CLINTON CSO
STORAGE FACILITY PROJECT

CONTRACT NO. 7
BID REFERENCE NO. 7234
PROJECT NO. 587960

COUNTY OF ONONDAGA
DEPARTMENT OF WATER ENVIRONMENT PROTECTION

RECORD DRAWING

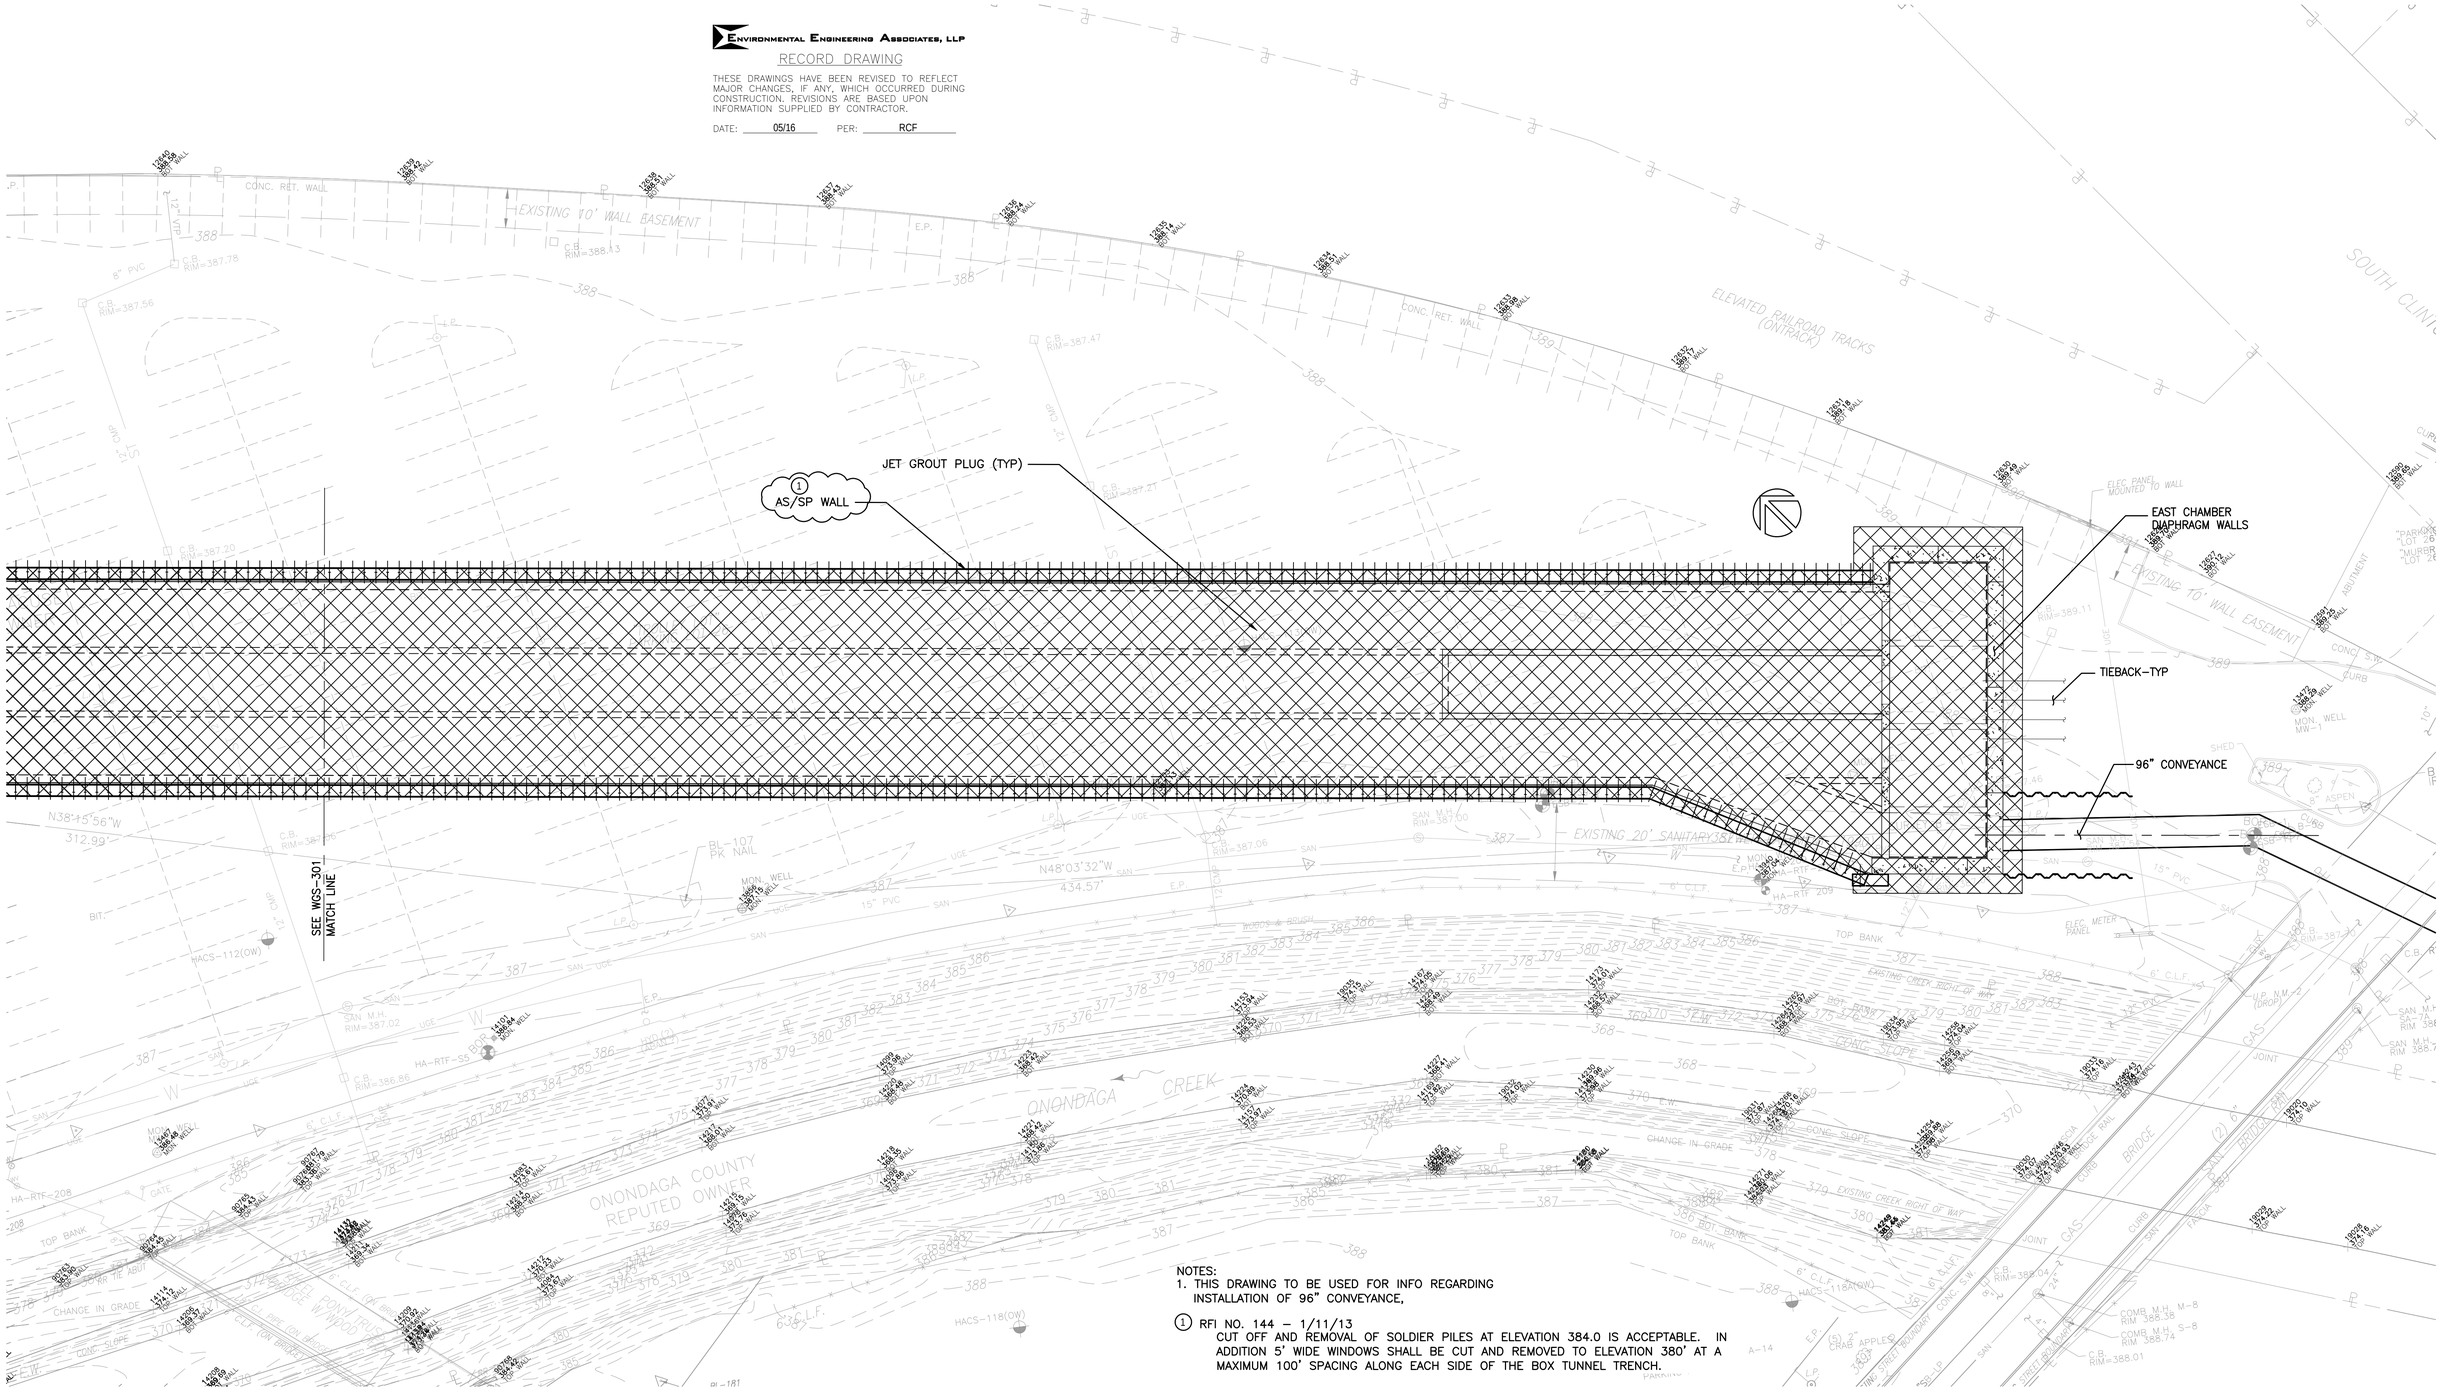
(1) RFI NO. 144 – 1/11/13
CUT OFF AND REMOVAL OF SOLDIER PILES AT ELEVATION 384.0 IS ACCEPTABLE. IN ADDITION 5' WIDE WINDOWS SHALL BE CUT AND REMOVED TO ELEVATION 380' AT A MAXIMUM 100' SPACING ALONG EACH SIDE OF THE BOX TUNNEL TRENCH.

1 A110 WALL SECTION
SCALE : 3/4" = 1'-0"

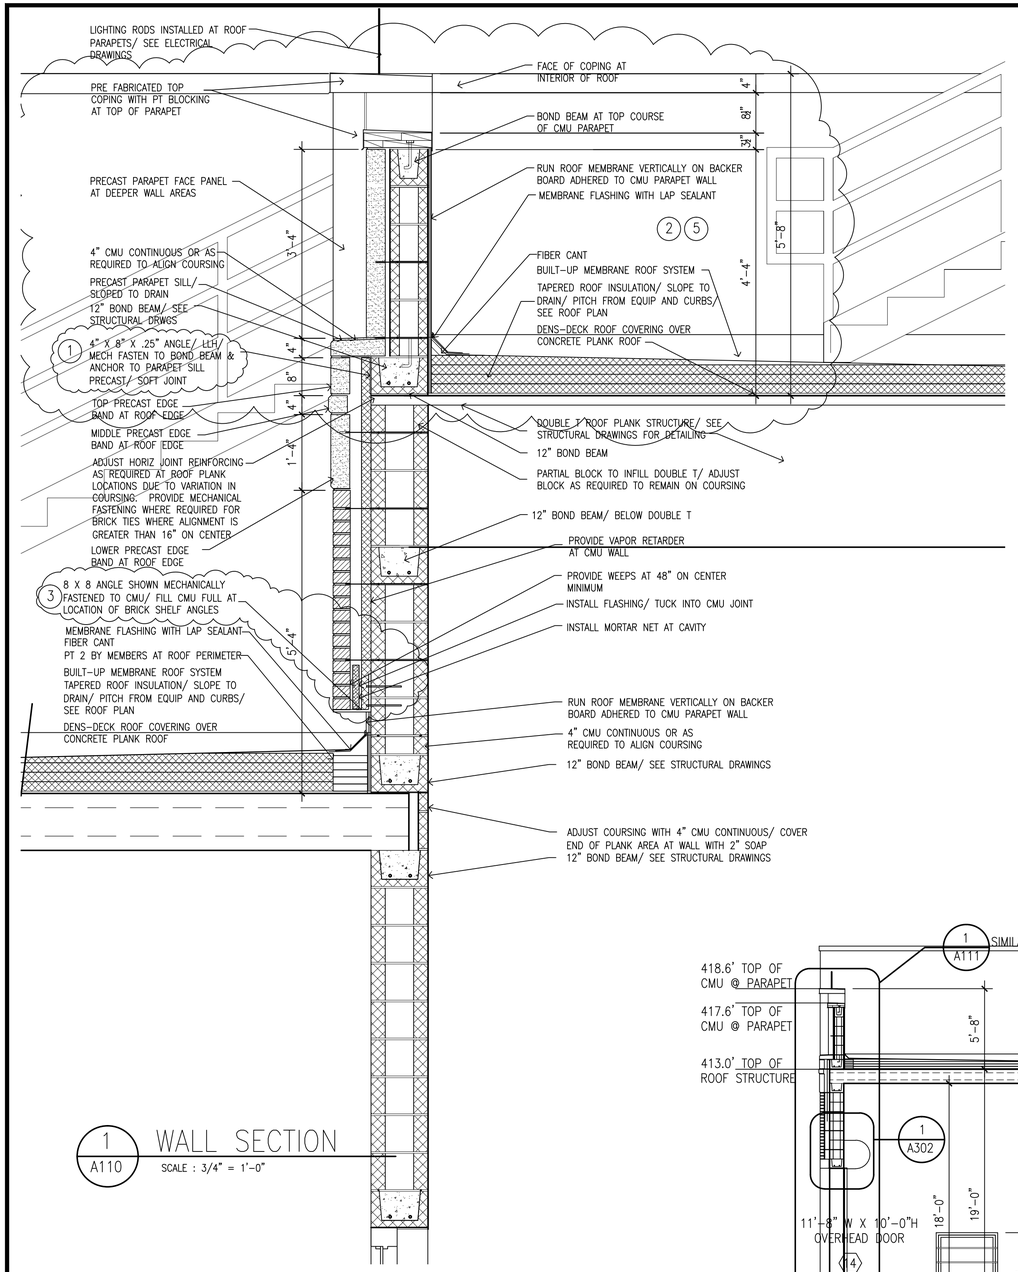
1. RFI #116; 1-11-2013:
8" x 8" x 3/8"

3. RFI #275; 9-05-2013; BRICK SHELF ANGLE:
– IT WOULD NOT BE ACCEPTABLE TO UTILIZE AN L8x4 SHELF ANGLE AS PROPOSED. THE 8" VERT LEG IS NEEDED STRUCTURAL STABILITY, THEREFORE, IT CAN'T BE SHORTENED.
– CONTRACTOR SHALL NOTE THAT ALL THESE SHELF ANGLES SHOWN ON THE ARCHITECTURAL DRAWINGS SHALL BE SIZED AND ATTACHED IN ACCORDANCE WITH THE SHELF/ANGLE DETAILS PROVIDED ON CONTRACT DRAWING S-003.

5. RFI #279; 8-30-2013; DRAWING A-101; PRECAST ELEV ABOVE STAIRS:
SEE DRAWING THIS SHEET

1 WALL SECTION
1/A111
SCALE : 3/4" = 1'-0"

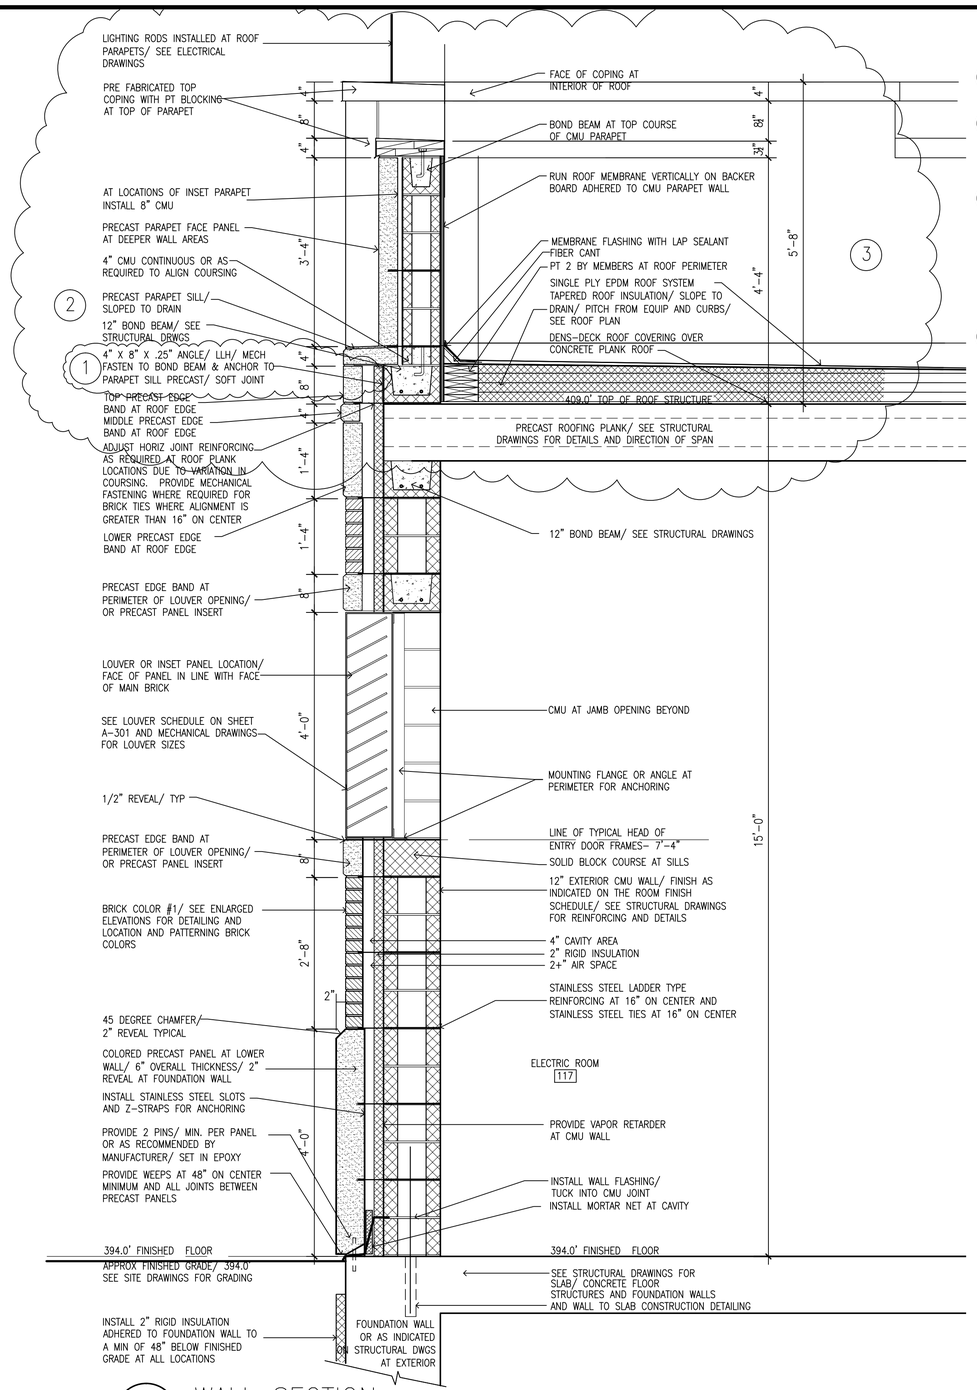
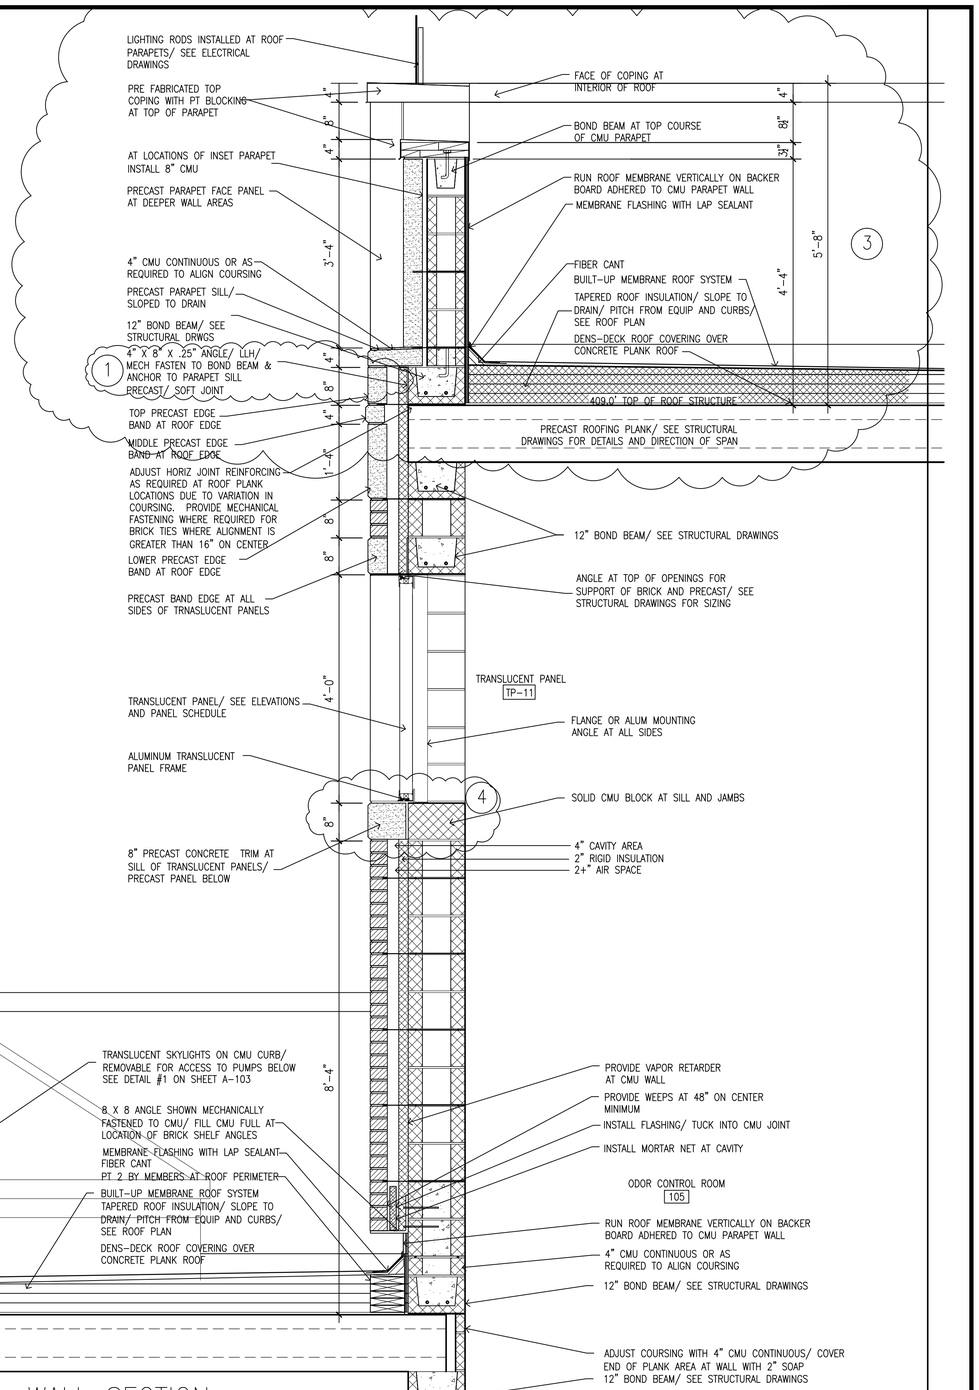
1. RFI #116; 1-11-2013: 8" x 8" x 3/8"
2. RFI #129; 1-11-2013: TO SUPPORT THE LOUVER IN THE OPENING REFER TO SHEET S-003 PARAPET SHELF ANGLE. THE ANGLE WILL BE 4"x8" IN LIEU OF 8"x8" NOTED IN THE DETAIL.
3. RFI #272; 8-28-2013; CARLISLE ROOFING RECOMMENDATIONS: ITEM No 1 – ANCHOR BOLT LENGTH OF 6" IS ACCEPTABLE, BUT THIS LENGTH SHOULD BE VERIFIED FOR VARYING CONDITIONS. ALL BLOCKING IS TO BE PRESSURE TREATED. ITEM No. 2 & 3 – THIS STATEMENT IS ACCEPTABLE. COMPLY WITH CARLISLE DESIGN DETAILS TO MEET COMPANY REQUIREMENTS AND COMPLY WITH WARRANTY REQUIREMENTS. SEE ALSO DETAILS ON SHEET A-110
4. RFI #251; 7-30-2013: SUPPORT ANGLE REQUIRED-SEE FIELD ORDER #43.

GRADE LEVEL PLAN
SCALE : 1/4" = 1'-0"
PROVIDE GRAFFITI RESISTANT COATINGS AT ALL ELEVATIONS TO BRICK AND PRECAST MATERIALS. SEE SPECIFICATIONS FOR FURTHER MATERIALS AND APPLICATIONS

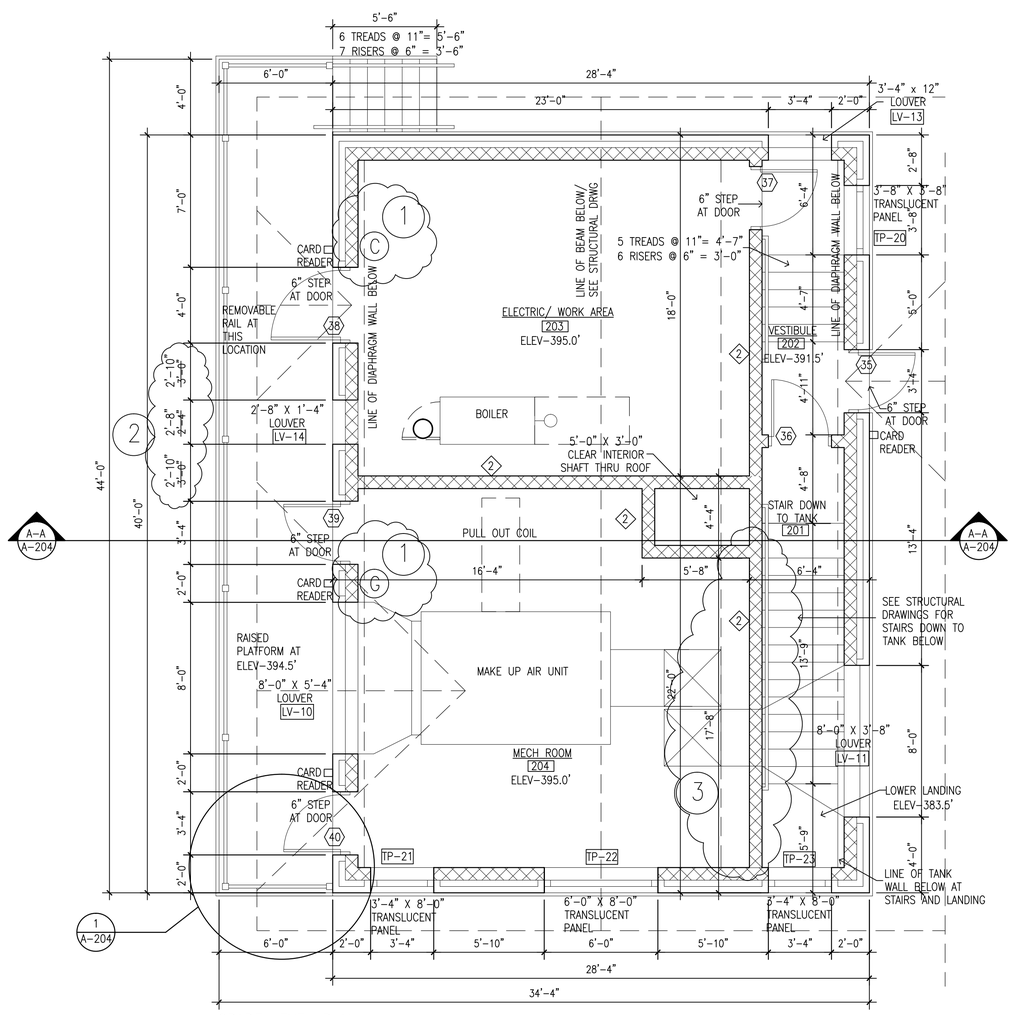
(1) ENGINEERS FIELD ORDER #58; FEBRUARY 12, 2014:
FIRE EXTINGUISHER LOCATIONS:
1.) MOUNT TOP OF BRACKET @ 4" AFF
2.) INSTALL WHERE INDICATED & AS NOTED w/ SIGNS TAPED ON WALLS IN THE BUILDINGS.
Ⓒ – C02 F.E. Ⓖ – GENERAL PURPOSE F.E.

(3) RFI #307; 11-19-2013:
AT THE REQUIRED DUCT PENETRATION BETWEEN ROOM 204 AND STAIRS 201, SAWCUT THE REQ'D MASONRY OPN'G AND INSTALL A MASONRY LINTEL. PROVIDE A 16" DEEP (2) COURSE LITEL FOR A 4'-0" MASONRY OPN'G AT THE EAST STRUCTURE IN ACCORDANCE WITH "MASONRY LINTEL SCHEDULE" ON DRAWING S-003. PROVIDE MIN 8" BEARING AT EACH END OF THE LINTEL. BOTTOM BARS SHOULD HAVE A STANDARD 90 DEGREE HOOK @ EACH END. DO NOT CUT TOP OF WALL BOND BEAM REINFORCING BARS.

S-101

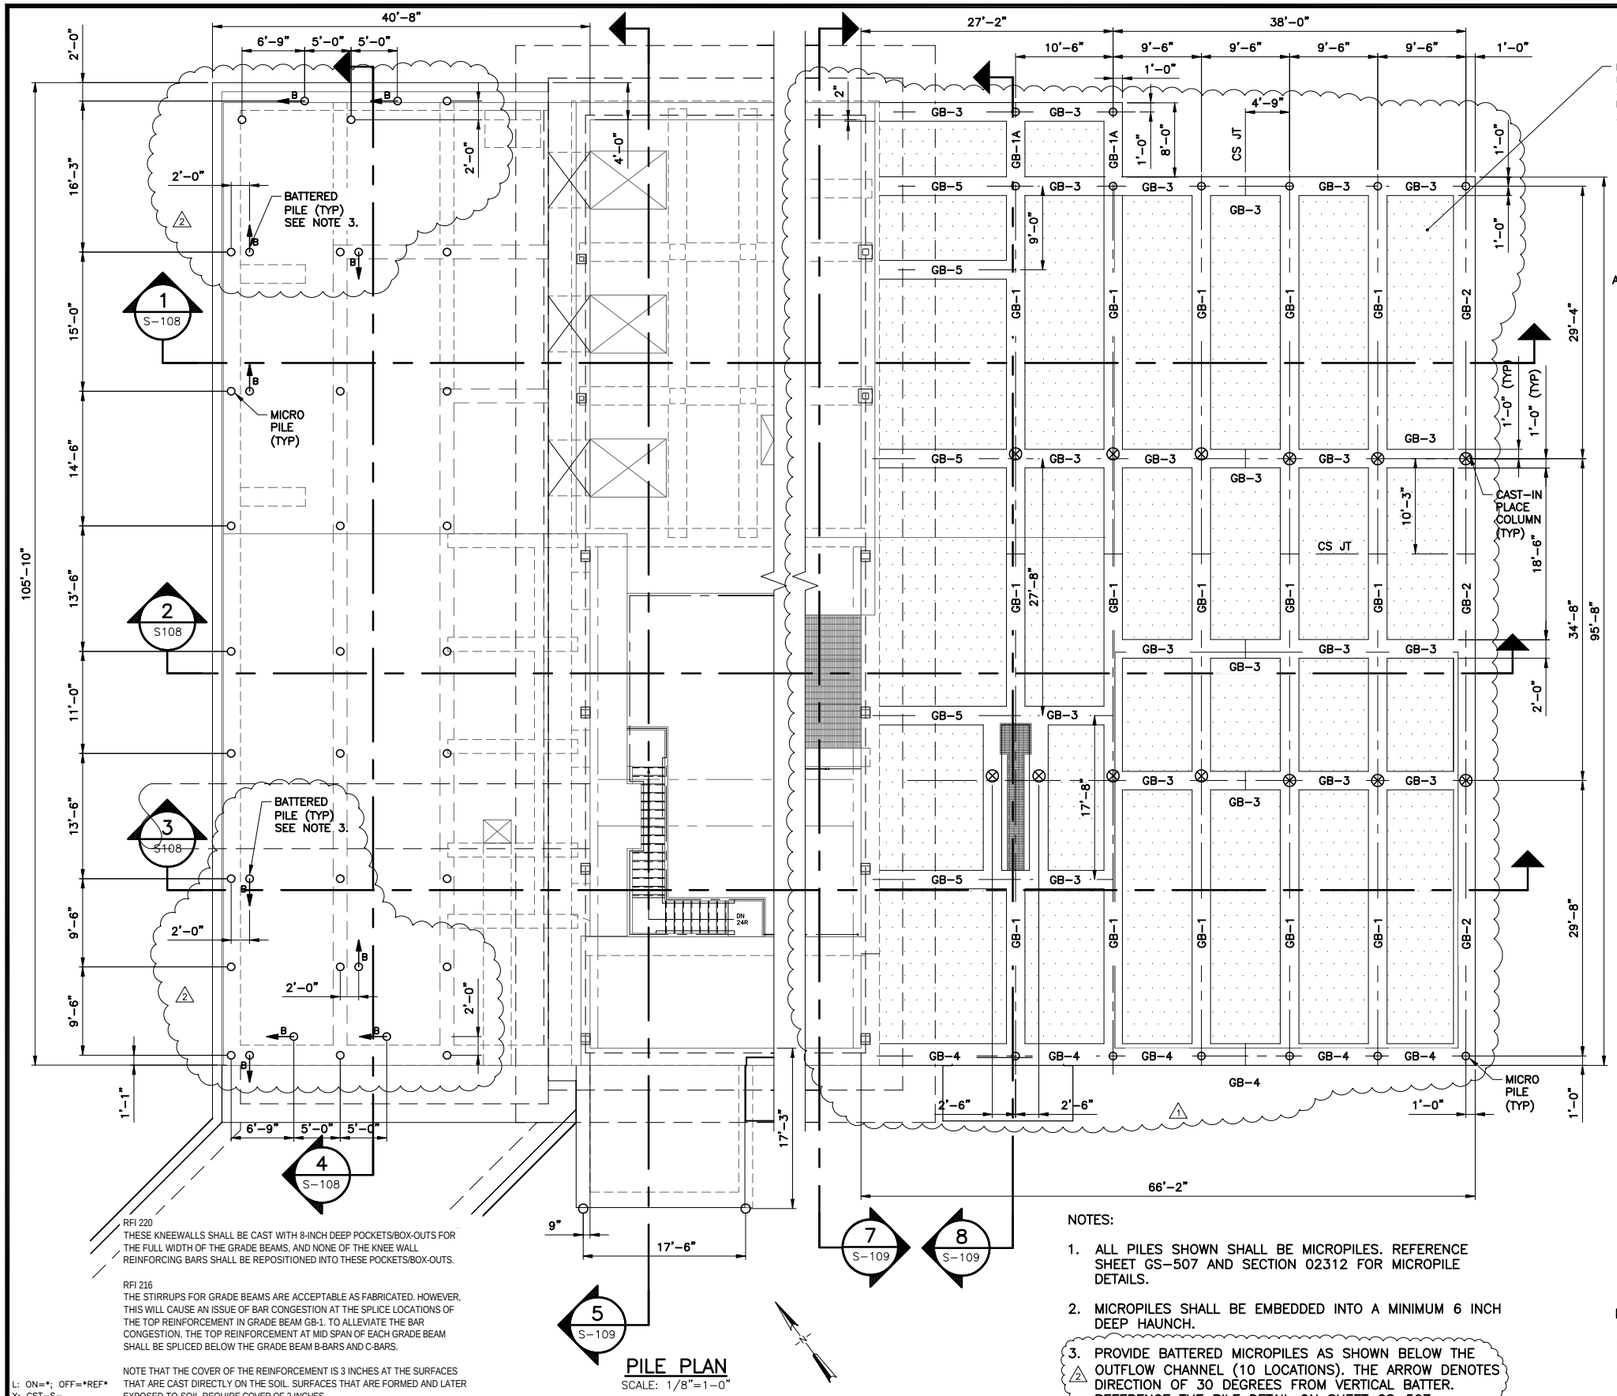
RFI 220
THESE KNEEWALLS SHALL BE CAST WITH 8-INCH DEEP POCKETS/BOX-OUTS FOR THE FULL WIDTH OF THE GRADE BEAMS, AND NONE OF THE KNEE WALL REINFORCING BARS SHALL BE REPOSITIONED INTO THESE POCKETS/BOX-OUTS.

RFI 216
THE STIRRUPS FOR GRADE BEAMS ARE ACCEPTABLE AS FABRICATED. HOWEVER, THIS WILL CAUSE AN ISSUE OF BAR CONGESTION AT THE SPLICE LOCATIONS OF THE TOP REINFORCEMENT IN GRADE BEAM GB-1. TO ALLEVIATE THE BAR CONGESTION, THE TOP REINFORCEMENT AT MID SPAN OF EACH GRADE BEAM SHALL BE SPLICED BELOW THE GRADE BEAM B-BARS AND C-BARS.
